SF714

Subject: eCascadia eAxle Spring Seat

Models Affected					
Make	Model	Model Yr. Start	Model Yr. End	Prod. Start Date	Prod. End Date
Freightliner	eCascadia	2023	2025	February 23, 2022	November 27, 2024
Identifying Feature	Incorrectly installed eCascadia eAxle Spring Seat.

Fig. 3, Abrasion on the High-Voltage Cable Outer Cover

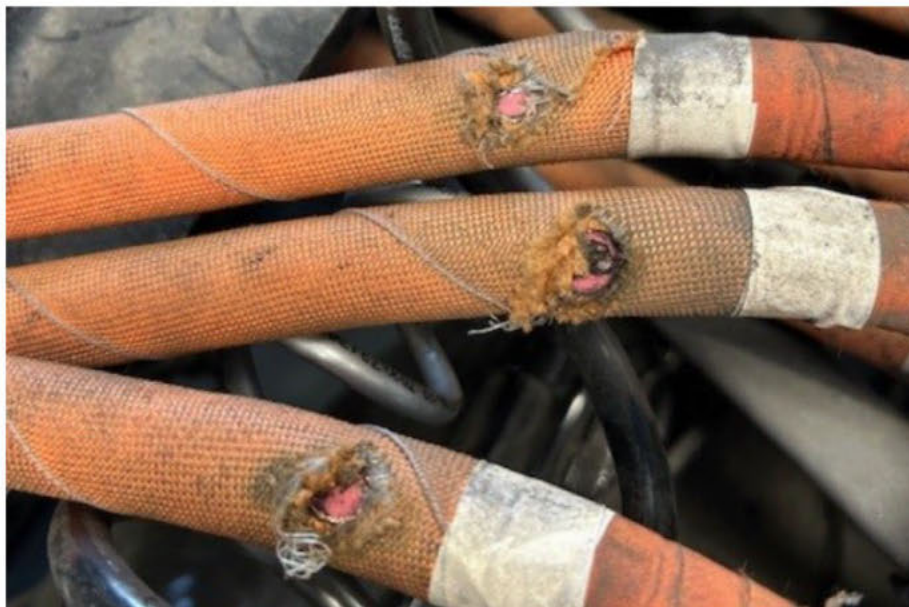
14. Slide the fifth wheel to the forward-most position to expose the high-voltage cable routing from the chassis to the rear drive axle.
15. For all axles with spring seats installed backwards, inspect the high-voltage cables for evidence of rubbing abrasion between the axle and frame-side support bracket, as shown in [Fig. 3](#).

Do the high-voltage cables have evidence of abrasion to the outer cover?

YES → Replace the damaged high-voltage cables. For instructions, see **Group 8** of the *eCascadia Workshop Manual*. Then go to step 16.
